Subject: RATTLE, SNAP, POP OR CRACK NOISE FROM BOTTOM OF A-PILLAR	Bulletin No: 09-001/14
	Last Issued: 08/01/2014

- This bulletin supersedes the previous bulletin 09-001/14, issued on 01/08/14 and 03/28/14. The APPLICABLE MODEL(S)/VINS, REPAIR PROCEDURE, and WARRANTY INFORMATION have been revised.
- Changes are noted below in Red beside the change bar.

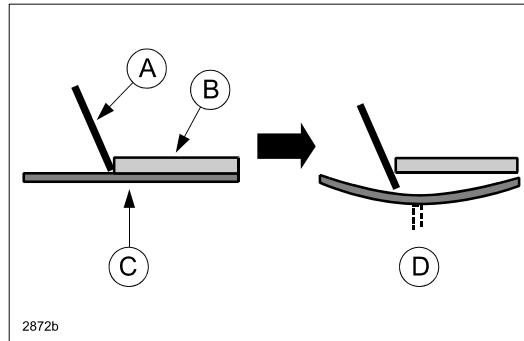
- Place the tip of a covered* flat-blade screwdriver (A) between the wiper bracket (B) and the dash upper panel/cowl upper plate (C) and hit the head of the screwdriver with a hammer to create a clearance of approximately 0.5 mm (D) between the two.

***NOTE:** To avoid damage to the paint, wrap protective tape around the tip of the screwdriver. If the panels are scratched, apply appropriate corrosion protection primer.

Locations to create clearance

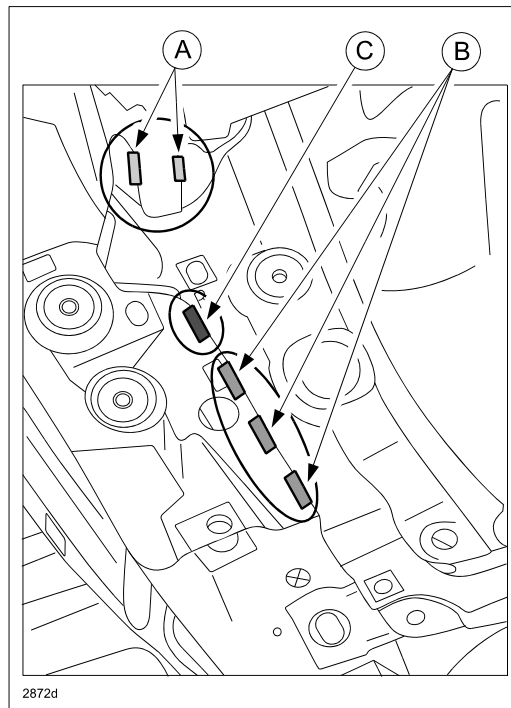
- Areas A and B: Create a clearance for all vehicles
- Area C: Create a clearance for vehicles with VIN range JM1BM*****100001 - 189735

Area A for all vehicles

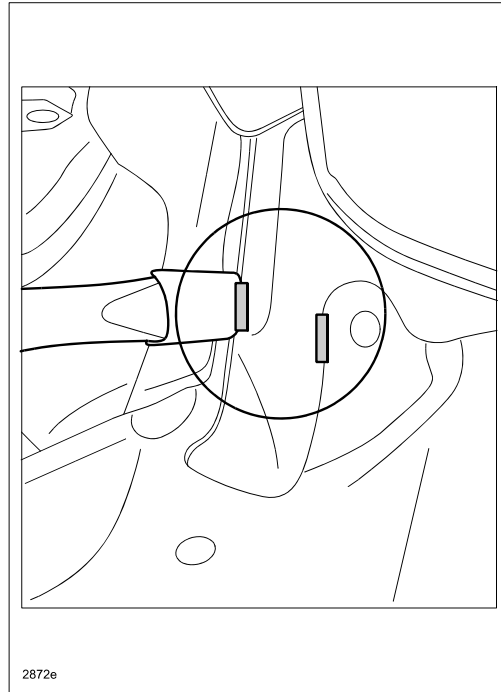
5. Apply a body adhesive to Area A between the wiper bracket and the dash upper panel (at the two locations shown).
